City of Santa Fe, New Mexico

memo

2026-012284-HDRB. 1062 Camino San Acacio, Downtown & Eastside Historic District, contributing, Gabriel Browne, agent/owner, proposes to replace windows and doors and install exterior insulation on the contributing structure. Construct a 3,440 sq. ft. freestanding residence to a height of 20'-9", where the maximum allowable is 16'-9". Construct a 733 sq. ft. guesthouse with a pitched roof and construct a 6'-0" high fence and a 4'-0" high yard wall. Additional height is requested due to slope per section 14-4.6(F)(2)(II)(f). Exceptions are requested to section 14-4.6(E)(4)(II) for placing a new architectural finish on a primary facade and for using material not in keeping with the district.

Figure 3: Primary Façade Diagram

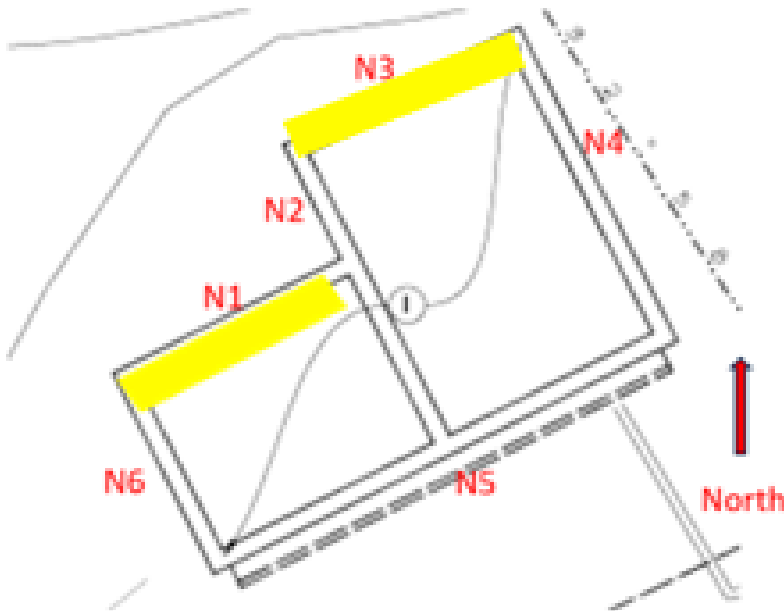
Exception to 14-4.6(E)(4)(II)(a): The applicant requests an exception to “*Architectural features, finishes, and details other than doors and windows shall be repaired rather than replaced.*” The request is for placing an exterior insulation on the primary façade of a contributing structure

Applicant Response: The addition of 4” of foam to these two facades will not damage the character of the district. This would be a very subtle change, not perceptible by the casual observer. Adding proper insulation enhances the utility and value of the structure, and assures its longevity and thereby its contribution to the character of the district.

Staff Response: The staff finds that this criterion is not met. Placing exterior insulation on a building alters its appearance on the exterior. The insulation is a smooth surface with sharp corners. Adobe structures have soft corners and some irregularities to the surface of the building. To eliminate this feature for a smooth, even surface is to remove the unique character of the adobe building and therefore damage the character of the district.
